Subject: **Palo Verde Nuclear Generating Station  
Units 1, 2, and 3  
Docket Nos. STN 50-528, 529, and 530  
Response to Request for Additional Information (RAI) -  
Request for Relief from the American Society of Mechanical  
Engineers (ASME) Code, Section XI, Reactor Vessel Head  
Flange Seal Leak Detection Piping - Relief Request 49**

**APS Response to NRC Request for Additional Information  
(RAI) - Relief Request 49**

**Request for Relief from the American Society of Mechanical  
Engineers (ASME) Code, Section XI, Reactor Vessel Head  
Flange Seal Leak Detection Piping**

**PALO VERDE**  
NUCLEAR GENERATING STATION

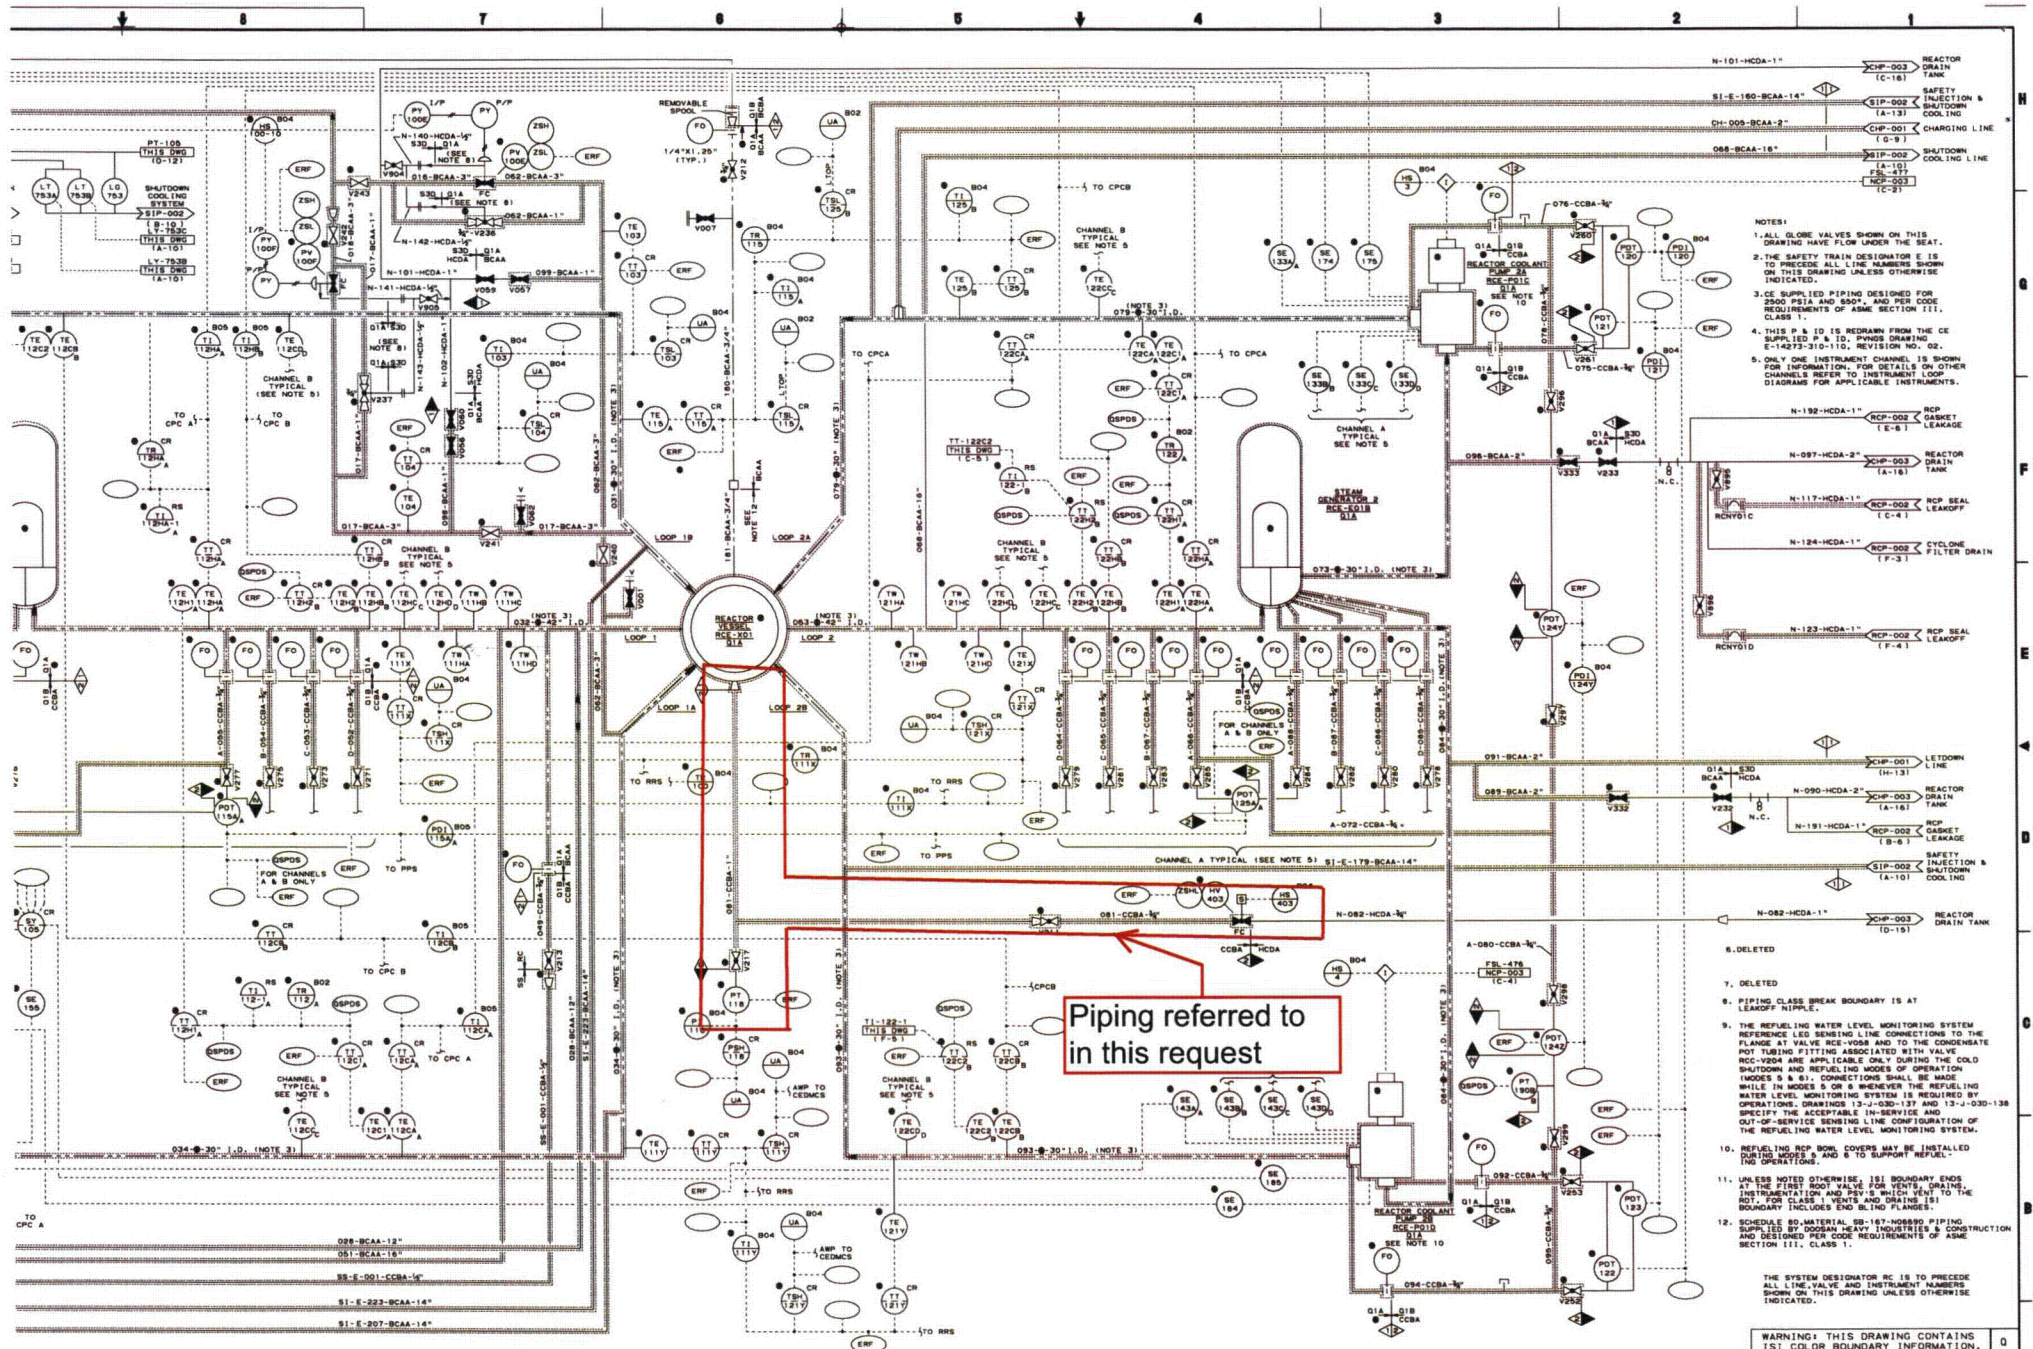
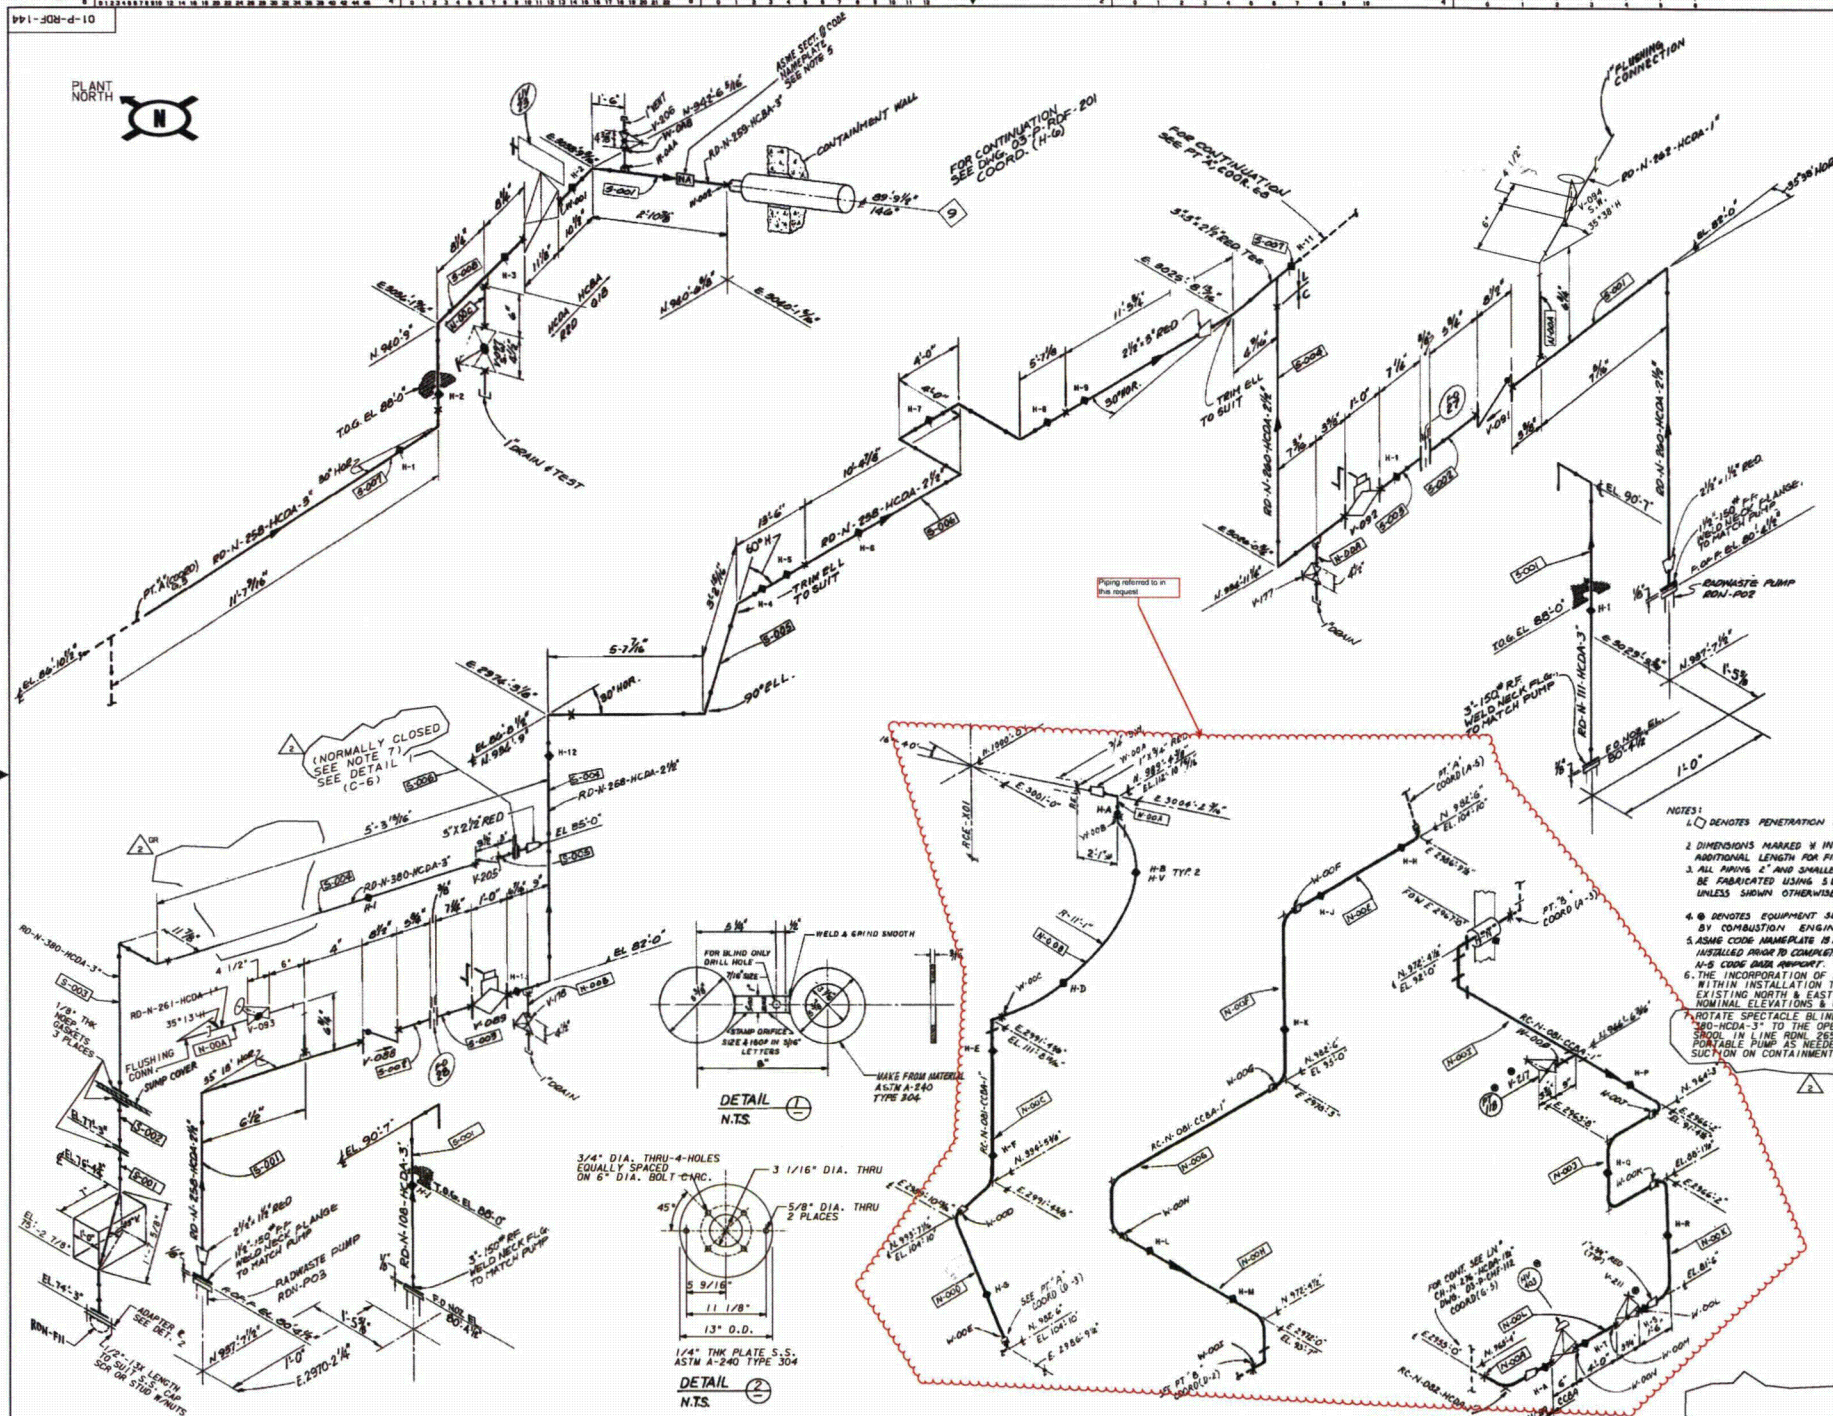
Provide a piping and instrumentation diagram (P&ID) and a piping isometric drawing showing the RPV flange seal leak detection piping.

The requested piping and instrumentation diagram (P&ID) and the piping isometric drawing showing the RPV flange seal leak detection piping is provided as Attachment 1 of this Enclosure.
